24/01006/DISCON

Drainage Supporting information received by email 21 January 2025

Flood maps for planning;

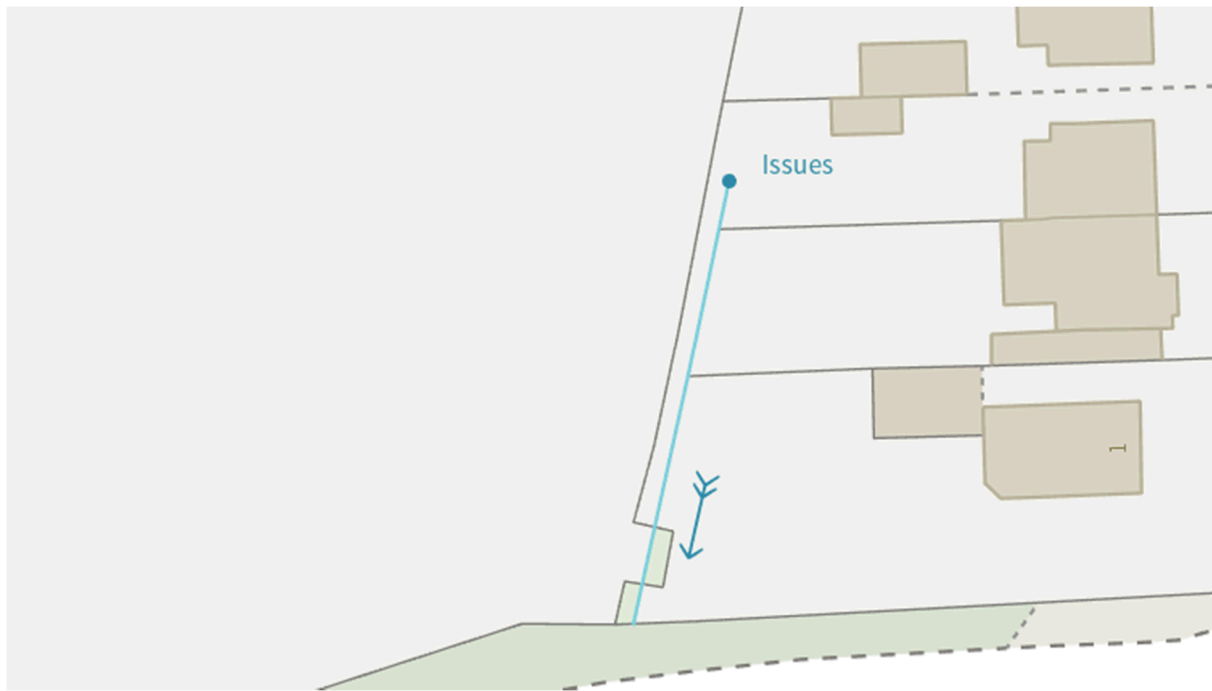
Also with regards to the looking into connecting within the ditch as suggested within you the comments in your original email please see the below extracts that the ditch sits outside of our control within third party land and does not abut our boundary meaning there is not a viable connection; please note we have followed the drainage strategy that was issued within the outline of the development.
